MODEL:	TYPE:	SECTION/GROUP:	DATE:
D Series	Field Change Program	07- Electrical	May 28, 2018

SEAT BELT BUCKLE FIELD REPLACEMENT INSTRUCTIONS

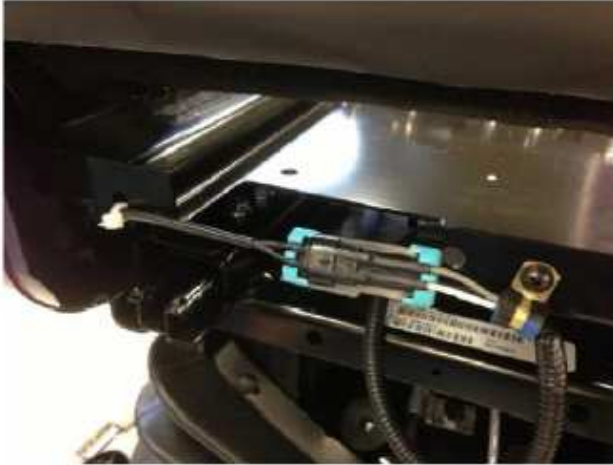
1. Remove the hole plugs from lower rear trim panel using small pick. Save for re-use. Remove rear lower trim panel using Phillips #2 screwdriver. Set aside caps, screws, and panel.
